F.2 <u>844 Johnson Street - Development Permit with Variance Application No.</u> 00056 (Harris-Green)

Development Permit with Variance Application No. 00056 for 844 Johnson

Project Name
844 JOHNSON STREET - EXTERIOR UPGRADES

RE: DPV Revised Application Submission 844 Johnson Street, Victoria, BC

Sketch Title
ELEVATIONS

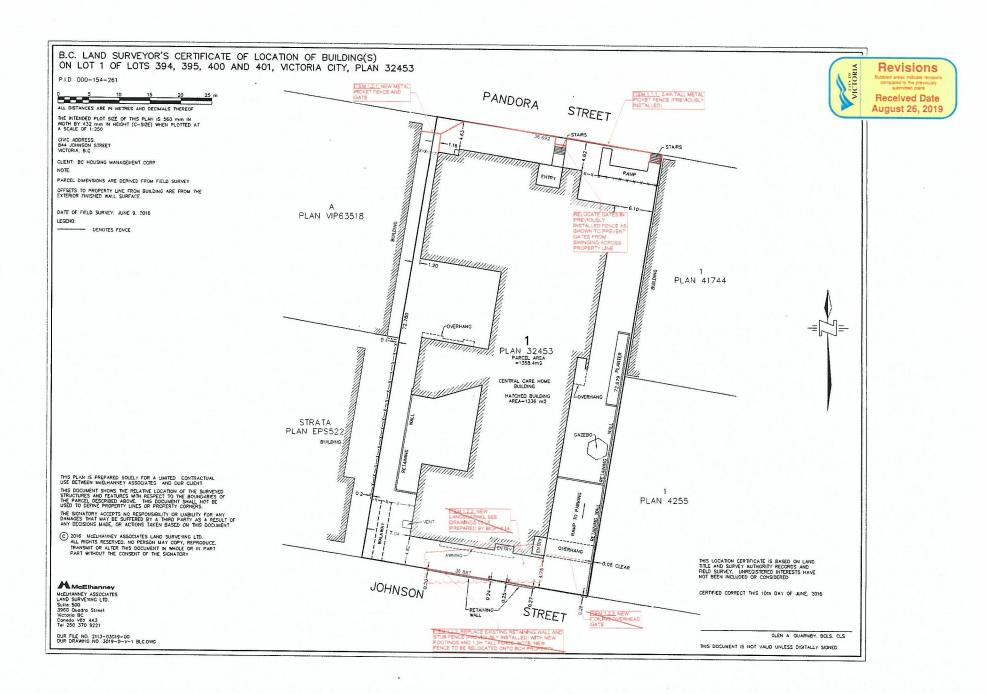
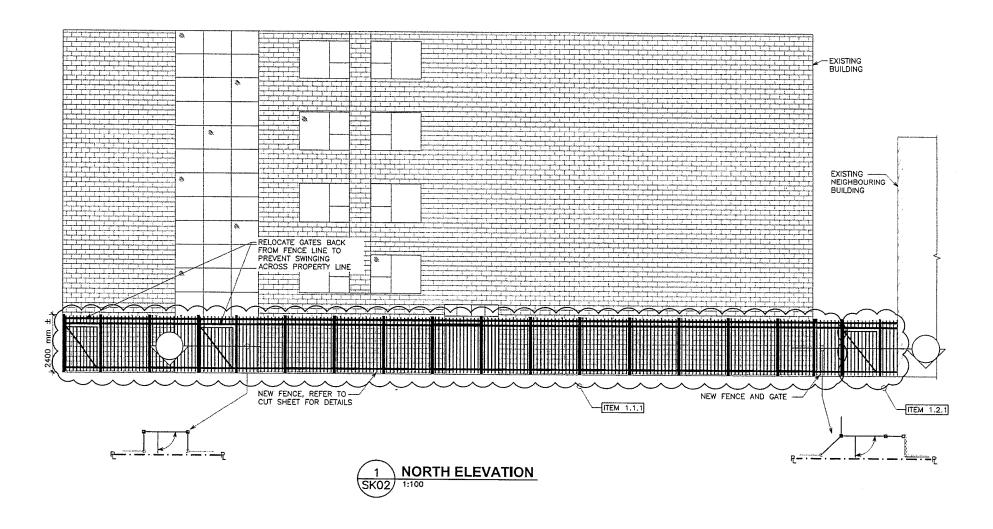
The purpose of this report is to present Council with information, analysis and recommendations for a Development Permit with Variance Application for the property located at 844 Johnson Street. The proposal is to vary the *Fence Bylaw* to permit an existing 2.40m fence located within the front (Pandora Avenue) yard of the subject property and to approve the overall design of the fence.

- the fence is inconsistent with the Guidelines for Fences, Gates and Shutters
- the fence is inconsistent with the Building and Street Interface Guidelines found within the Downtown Core Area Plan
- the proposed increase in height of the fence from 1.22m to 2.40m within the front yard is not appropriate as it detracts from the public realm and creates a fortress-like appearance to the property.

The existing fence on the Pandora Avenue frontage does not meet the design guidelines found within the *Guidelines for Fences, Gates and Shutters*. The guidelines note that fences and gates must not contribute to a "fortress" appearance from the street. The fortress-like appearance is a result of the excessive height and the spear-like tips at the top of the fence. Approval of this fence could also set a design standard in which other buildings along Pandora Avenue install similar fences, which would contribute to the public's perception of whether the street or area is safe or not.

Fences, Gates, and Shutters and creates a 'fortress' like appearance to the street that is not attractive along Pandora Avenue." BC Housing understands this feedback, however they wish to proceed to the Committee of the Whole based on the following:

- 1 Black fencing is a commonly used and classic combination with brick-clad buildings in Victoria and we believe it integrates with the building design and architectural finishes.

- .2 The large existing trees on the Pandora side of the building are a dominant feature and help conceal the fence. The shade due to the trees and northern exposure on this side of the building also help the fence blend in.

- .3 The fence is constructed of high quality, durable materials and cannot be damaged or cut as easily as other materials such as chain-link. As well, the pickets do not facilitate climbing as chain-link would. In addition, the pickets still allow for a substantial amount of transparency through the fence and do not create a solid surface or wall.

- .4 The fence design is similar to fencing installed at the neighbouring Central Baptist Church (833 Pandora) which we believe integrates this fence with the surrounding buildings and fences.

In order to address the comments from the Engineering, Permits and Inspections, and Fire departments, the existing two (2) gates in the fence will be relocated back from the line of the fence (i.e. in an alcove) to allow for the gate to still swing in the direction of travel, but not cross the property line or affect public right-of-way on the adjacent sidewalk.
